**CALIFORNIA COASTAL COMMISSION**

**PROPOSED FINDINGS**  
**ON CONSISTENCY DETERMINATION**

Consistency Determination No.	<b>CD-046-06</b>
Staff:	MPD-SF
File Date:	6/9/0226
60th Day:	8/8/2006
75th Day:	8/23/2006
Commission Vote:	8/11/2006
Hearing on Findings:	10/15/2006

**DEVELOPMENT DESCRIPTION:** Phase II of Lower Mission Creek flood-control improvements: tidewater goby, flood control channel maintenance, pilot channel design, and landscaping plans (Exhibits 2-9)

Figure 3. Fish Enhancement Features

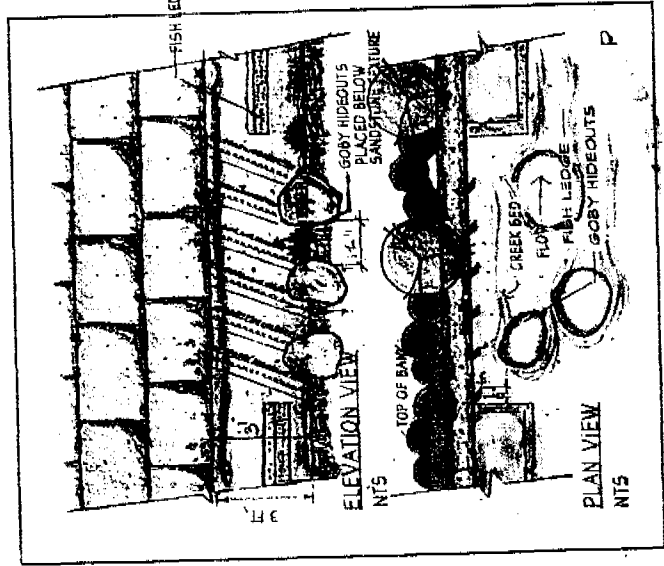
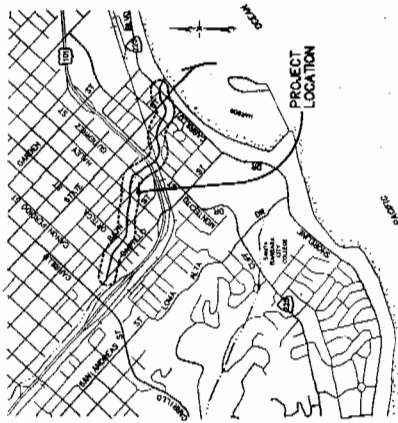
#### **Recommendation No. 4 - Remove Fish Ledges**

The Working Group engaged in several lengthy discussions about the proposed fish ledges. It was concluded that they would not be effective and should be removed from the design. The primary reason was that the ledges could become stranded over time if the low flow channel migrates to the other side of the larger channel, or the channel becomes lower. In these cases, the fish ledges would no longer be effective. The Working Group believed that the establishment of pools using the rock weirs would provide a greater amount of pool habitat that would be self-sustaining. Riparian and wetland plants are likely to persist or regularly colonize the channel bottom along the outside of the rock weir "arms" that extend downstream and form the pool, thereby creating cover for fish. The proposed fish ledges would have created 300 feet of cover for fish. The proposed 13 pools to be re-created during construction of the project would provide significantly habitat than would be created by the fish ledges, as the size of the pools below the rock weirs would range from 50 to 100 feet.

Figure 4. Channel Cross Section for the Lower Mission Creek Project - Blended Channel

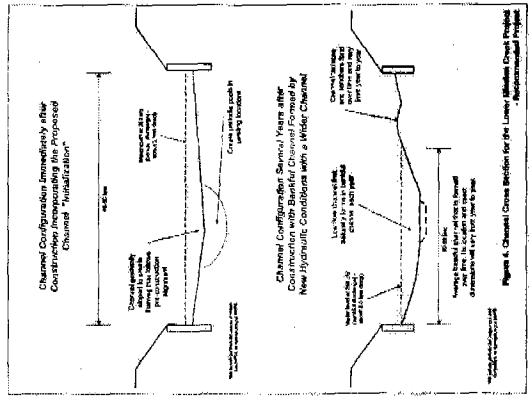
The channel between pools should be graded with a slight cross slope that reflects the location of the existing thalweg prior to construction (Figure 4). Hence, if the thalweg is located along the west bank, the new and wider channel would be graded with a slight grade (one foot or less over the width of the channel) towards the west bank. This action will enhance the formation of the low flow channel within the larger bankful channel.

Figure 6. Pool Cross-View Views

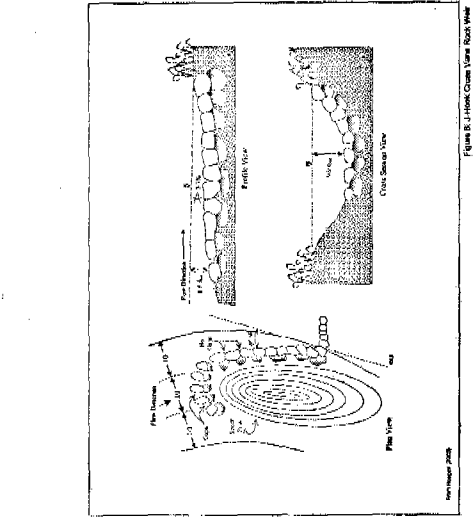
In curved portions of the creek, a "J-hook vane rock weir" would be installed, as shown on Figure 6.
